# HOWARD COUNTY HISTORIC PRESERVATION COMMISSION

# **February Minutes**

Thursday, February 4, 2021; 7:00 p.m.

Figure 16 - Rear elevation

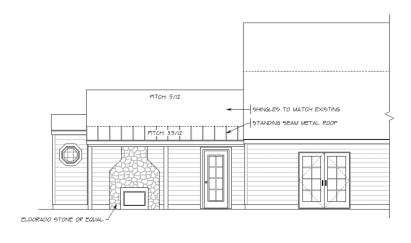
Ms. Zoren asked the Applicants to clarify the material facing the fireplace and chimney and asked if there was a photo of the El Dorado stone to be used. Mr. Swanson said the structure would be whitewashed brick and the fireplace will be ventless because it is outside. Ms. Zoren asked for clarification on the octagon window. Mr. Swanson said the window had been changed to a rectangular window. Ms. Zoren asked if the Applicant would continue the top part of the chimney up above the roof so the chimney looked like it was real. Mr. Swanson said that extending the chimney had not been discussed. Ms. Zoren asked for the other Commissioners to weigh in on the chimney length and design. Ms. Zoren said the shape and new window patterns were a big improvement.

Mr. Reich said the overall design of the addition fit and was compatible with the existing house. He asked for clarification on the dimensions of the HardiePlank siding, since the application states the siding will be in the same dimension and color of existing siding. Ms. Arthur clarified the HardiePlank siding was a half inch different than the existing siding. She noted there was a cedar shortage when the application was submitted and the closest siding was a HardiePlank with a 7-inch profile, while the original siding has a 6.5-inch profile. Ms. Arthur said she would make sure the HardiePlank siding would match the existing trim profile and color of the existing siding. If cedar siding could be found, it would be used instead. Ms. Holmes asked the Applicant if the proposal is still to use HardiePlank with the option to use cedar. Ms. Arthur said he would like to use cedar but there is a chance he would not be able to get it and would like HardiePlank as an option.

- 7) Approving 6x6 wood porch posts painted green to match the house and existing porch.
- 8) Approving Twilight II outdoor gas fireplace and white washed brick. Modification of the chimney to extend above the roofline to be submitted to Staff for approval.

**Second Motion:** Ms. Tennor moved to approve the windows as submitted in the subsequent revision that show double hung verses the arched windows and the removal of the octagonal window will now be a small double hung window. The Applicant will use cedar siding with the option to use HardiePlank siding if cedar is not available.

Figure 18 - Left side elevation

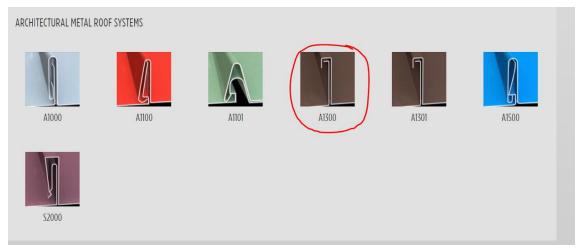
- 8) **Side porch roof** The drawings show a standing steam metal roof. The Applicant proposes to use an Englert metal roof system, in a color to be determined (possibly black or metallic copper). The proposed seam type is A1300, with a 1½ inch seam height spaced 20 inches apart.

Ms. Tennor agreed with the staff comments regarding the concrete slab porch floor and asked the Applicants to add a paver to the porch concrete slab as Staff suggested. Mr. Swanson said there is an existing concrete pad that currently leads to the front door. Ms. Tennor explained the paver would make the slab more historically appropriate and asked if the owner would consider it. Mr. Fitchett said it was something he considered doing after the project was completed. Ms. Holmes asked if the Applicant would modify their application to have a bluestone or slate paver on top of the concrete, since the Guidelines recommend against new slabs of concrete The Applicant, Staff and the Commission discussed Guideline requirements. The Applicant agreed to put stone pavers on top of the 4x2 concrete pad.

- 3) Asphalt shingle roof in the brown color and a shingle that matches the existing roof and 5 inch K-style black gutters.
- 4) The side porch, approve the revised metal standing seam roof profile to A1000

- 5) The concrete porch floor, the Applicant has agreed to add bluestone or slate pavers on top of the concrete.
- 6) Item 3, the solid vinyl soffit and ceiling has been modified to be a wood beadboard painted white like other trim.
